# Access Compliance Report

## Public Rights-of-Way

### (Curb Ramps)

Intersection ID: 16828	Main Street: BUCKNELL_AV	Cross Street: SELWYN_AV	Location: SE
ADA ID: 7F454081A52F	Ramp Type: Perp	Initial Pass/Fail: Fail	Overall Compliance: No
Severity Score: 12.5			
Codes/Mitigation Info/Possible Solution		Field Measurements/Component Compliance

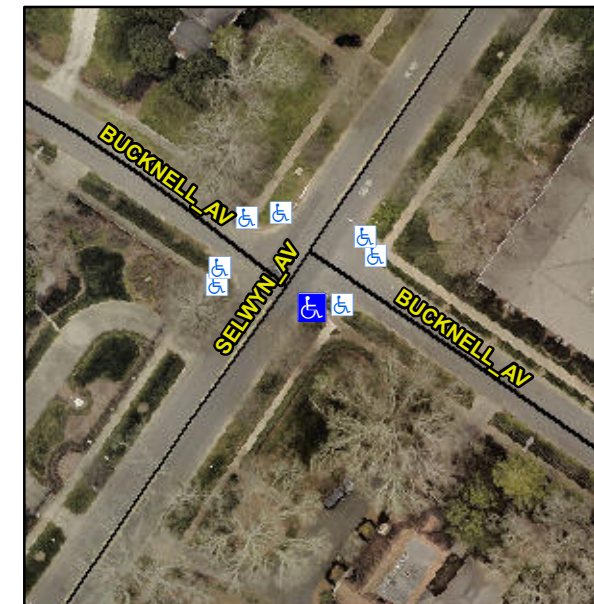
**R304.2.2**

Compliance	Description	Data	Compliance	Description	Data
N/A	Ramp Length (in)	86.0	No	Ramp Slope (%)	8.4
Yes	Ramp Width (in)	48.0	Yes	Ramp XSlope (%)	0.7
N/A	Flare Type LT	N/A	N/A	Flare Type RT	N/A
N/A	Flare Slope LT (%)	N/A	N/A	Flare Slope RT (%)	N/A
N/A	Flare Traversable LT?	N/A	N/A	Flare Traversable RT?	N/A
N/A	Landing Length (in)	N/A	N/A	DWS Provided?	N/A
N/A	Landing Width (in)	N/A	N/A	DWS Contrast?	N/A
N/A	Landing Slope (%)	N/A	N/A	DWS Length (in)	N/A
N/A	Landing X Slope (%)	N/A	N/A	DWS Full Width?	N/A
N/A	Landing Curb? (Y/N)	N/A	N/A	DWS Offset (in)	N/A
N/A	Shared Landing?	N/A			
N/A	Gutter Ponding?	N/A	N/A	Gutter Slope (%)	N/A
N/A	Gutter Lip Ht (in)	N/A	N/A	Gutter X Slope (%)	N/A
N/A	Painted X Walk1?	No	N/A	Painted X Walk2?	N/A
	X Walk 1 Direction	To NW		X Walk 2 Direction	N/A
N/A	X Walk 1 Width (in)	N/A	N/A	X Walk 2 Width (in)	N/A
	X Walk 1 Slope (%)	4.8		X Walk 2 Slope (%)	N/A
	X Walk 1 X Slope (%)	0.1		X Walk 2 X Slope (%)	N/A

**Remove & Replace Entire Ramp.**
